August 23, 2021

## **RE: Submission of 2021 Geotechnical Inspection Report No. 1 (June 2021)**

Figure 12: Stable perimeter berms around PWS pond #3 – A small “floating” section of the liner is visible in the pond (yellow circle).

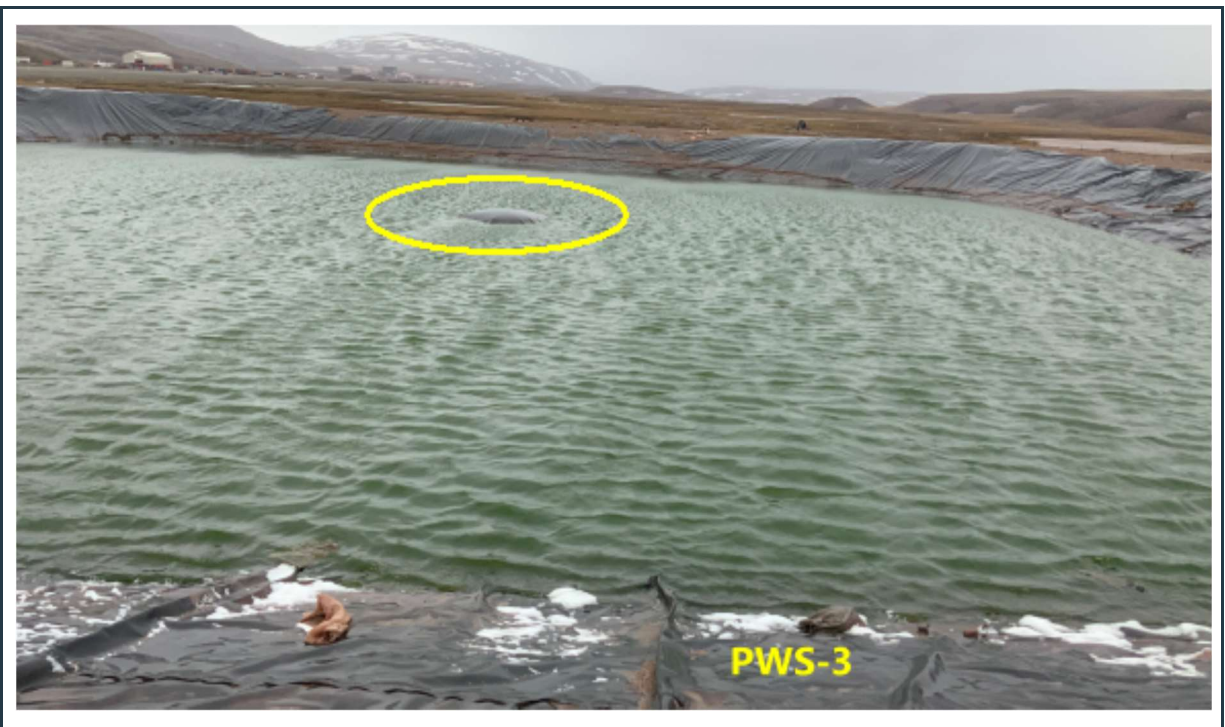
There are three (3) polishing/waste stabilization ponds, located adjacent to the runway, as shown in Figure 3. Pond #1 is a single structure, while Ponds #2 and #3 were constructed as twin-cells, as shown in Figure 9, which is a historic aerial image showing the robust berms around the ponds. According to previous inspection reports, these ponds were associated with the exploration phase of the mine, and currently serve as emergency holding ponds in case problems would arise, which would prevent the discharge of treated effluent directly to the receiving environment. The stable berms around the ponds generally comprise granular materials (rock fill, sand, and gravel), supporting High Density Polyethylene (HDPE) geomembrane liners. The liners are secured in anchor trenches on the crest of the berms, and no damage is visible on the membranes on the upstream face of the slopes (see Figures 10 to 12).

Figure 23: View of the recently completed MS-07 surface-water collection pond with robust, stable berms and intact liner.

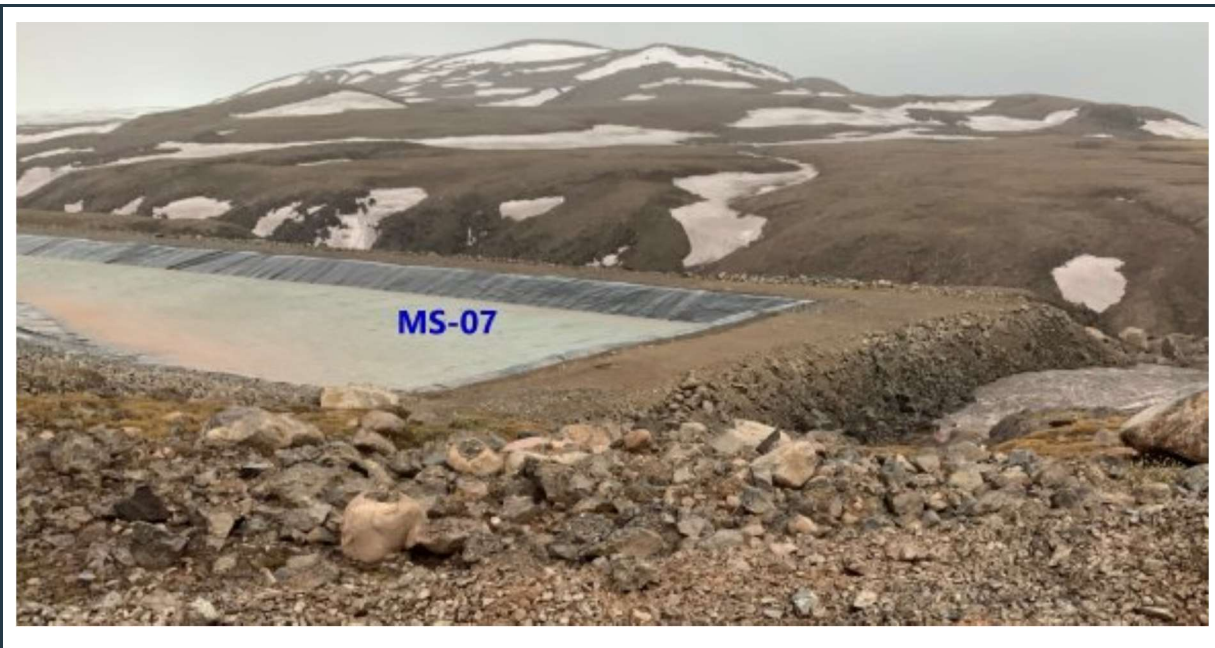
The MS-07 settling pond has been completed recently adjacent to the KM-106 ore stockpile area. The pond has robust perimeter berms and geomembrane liner, as shown in Figure 23. No stability or seepage related problems were observed at this pond during the recent site visit.

Figure 46: Berms and liner in good condition with stable slopes around the MP-01A pond. The waste (soil and wood), shown in one corner of the pond, should be removed (yellow circle).

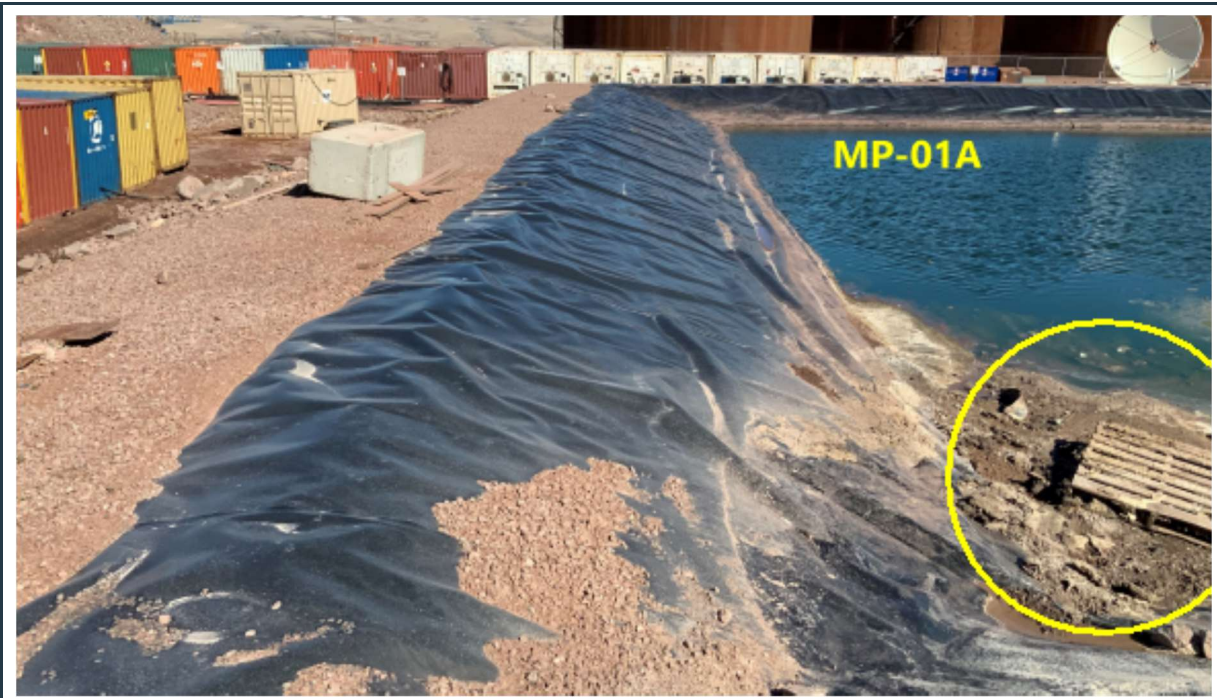
The MP-01A polishing waste stabilization pond is located immediately south of the MP-03 fuel tank farm. As shown in Figure 46, the berm around the well-maintained pond is in excellent condition and the liner appears to be intact. No sign of slope instability, settlement or seepage from the pond was noted during the field inspection. As shown in Figure 46; however, some settled soil sediment and a

Figure 50: View of the lined, stable berm along the west side of settling pond #3.

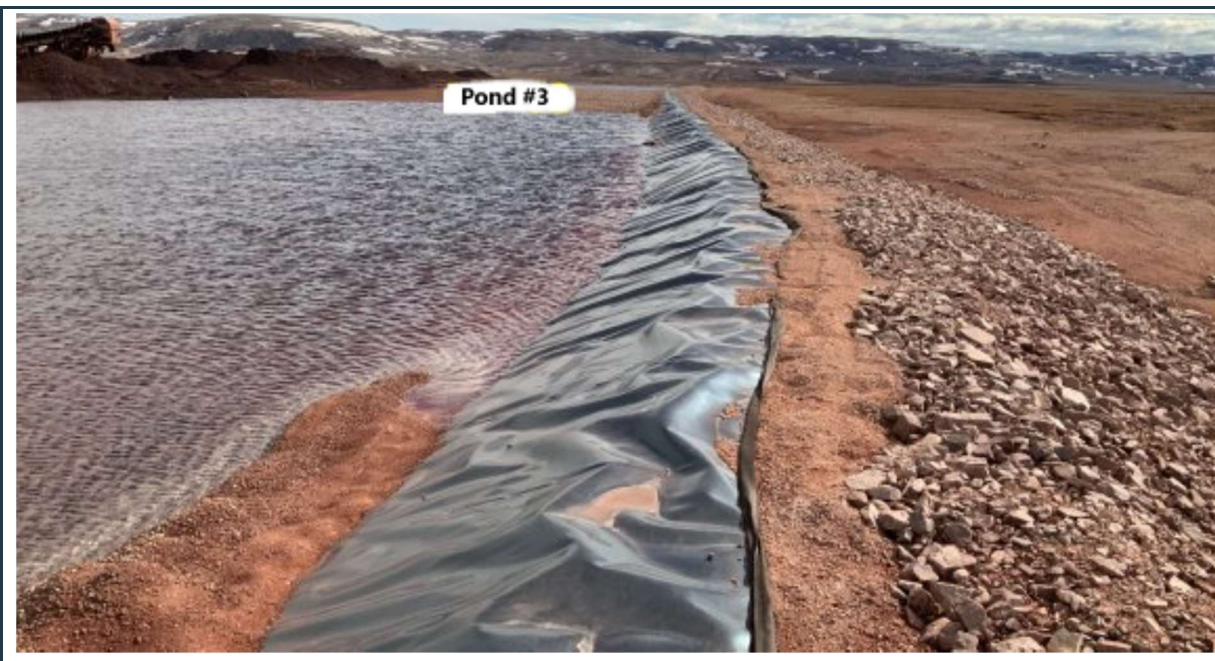
Settling Pond #3 was recently constructed west of the ore storage area, as shown in Figure 6. There are stable, lined berms along three (3) sides of the pond (Figure 50) that contains two (2) sumps. According to the design, the geomembrane and protective geotextile on the internal slope of the berms extend 2.5 m below the surface and are anchored into the permafrost zone to prevent any seepage from the pond into the ground below and around the pond. Excess water from the pond is pumped into the nearby, large capacity MP-06 settling pond if necessary.

Figure 51: Cracking on the surface along a few historic depressions adjacent to the berm of pond #3.

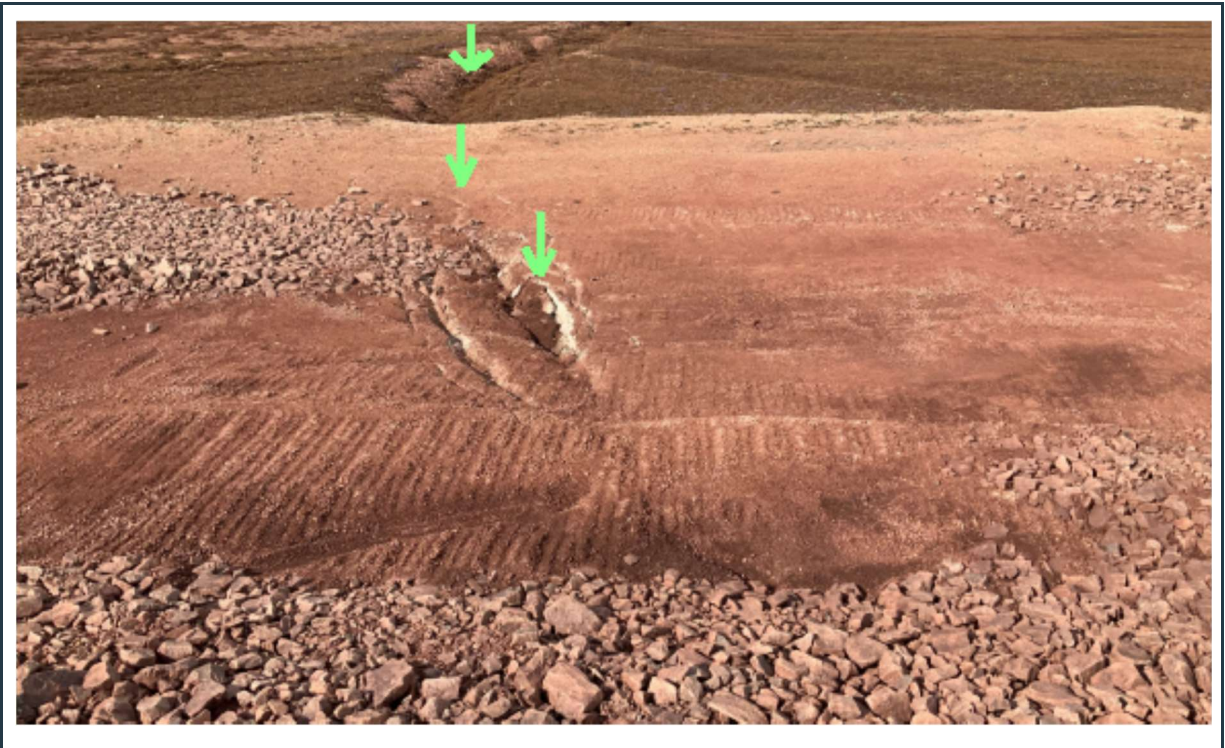
It should be noted that the surface cracks have no impact on the stability and integrity of the berms whatsoever. The cracks may seem somewhat wide locally; however, they do not extend too deep. It is also seen in Figure 51 that the cracks developed across areas where the thickness of the overlying fill is/was negligible. No cracks are visible across areas with thicker fill or within the berms. At this stage it is suggested that the cracks near the berm be filled with the same material that was used for the construction of the berms, to minimize ice-wedge development near the toe of the berms. The fill should be placed over the cracked areas within approximately 3 m of the downstream toe of the berms. It should be noted that such cracks will develop in other areas in the future; however, they represent no detrimental impact on the stability and integrity of the berms and the liner.

Figure 59: View of the "P-SWD-3 surface water collection ditch with failing side slope. The sloughing is caused by the uncontrolled water flow into the ditch along its alignment.

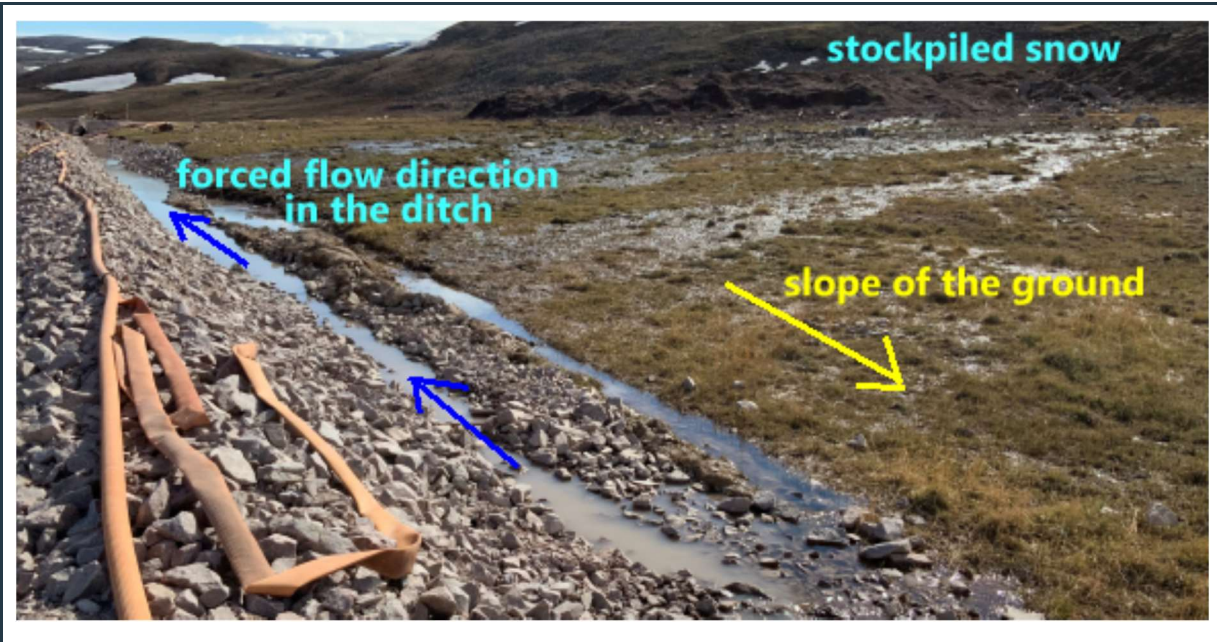
Sloughing of the sides of the P-SWD-3 ditch, adjacent to the LP2 laydown area, has occurred at several locations along the ditch. It is suggested that the existing condition of the P-SWD-3 drainage ditch and adjacent topography be re-evaluated in detail, and that the ditch be redesigned and reconstructed to drain the large amount surface water to the correct direction.

- As noted during last year's (2020) inspections and visible even more distinctively this year, sloughing of the sides of the P-SWD-3 ditch, adjacent to the LP2 laydown area, has occurred at several locations along the ditch, as shown in Figures 59 and 60. It is evident that the sloughing of the ditch's slopes is a direct result of uncontrolled sheet-flow of surface water (melting snow from the adjacent snow-dump and quarry diversion runoff), continuously flowing into the ditch that is not able to convey the collected water to a discharge location. As shown in Figure 59, the native ground adjacent to the ditch slopes toward south-west, while the ditch was designed and excavated to drain the water toward north-east; however, is currently not draining as designed. It is suggested that the existing condition of the P-SWD-3 drainage ditch and adjacent topography be re-evaluated in detail, and that the ditch be redesigned and reconstructed to drain the large amount surface water to the correct direction

Figure 62: Ponding water next to the P-SWD-6 - “Q01 South” surface water collection ditch.

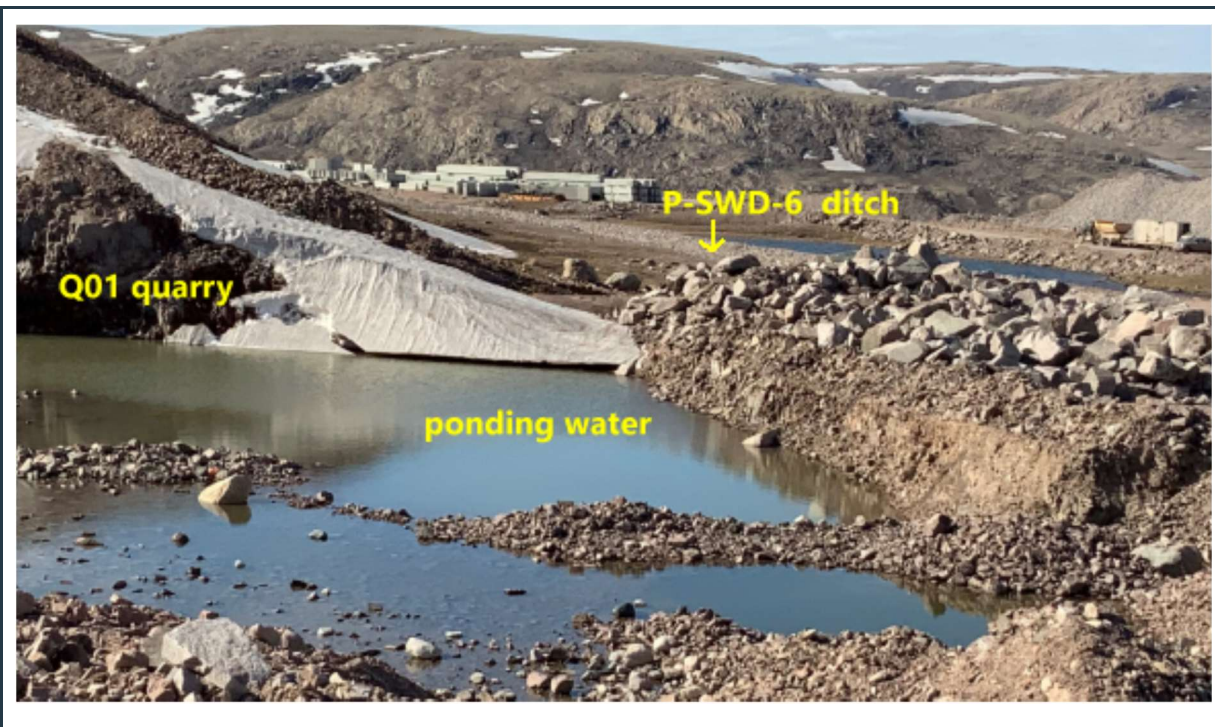
- The P-SWD-6 drainage ditch (Q01 South) was designed and constructed to collect surface water from the southern part of the rock quarry and convey the collected water toward the Tote Road. As shown in Figure 62, a section of the quarry was over-excavated somewhat and as a result seasonal ponding water is visible adjacent to the northern end of the ditch. Since the invert of the ditch is located at higher elevation it is suggested that a pump be installed, and the ponding water be pumped into the ditch whenever needed (most likely after snowmelt and after heavy rains).
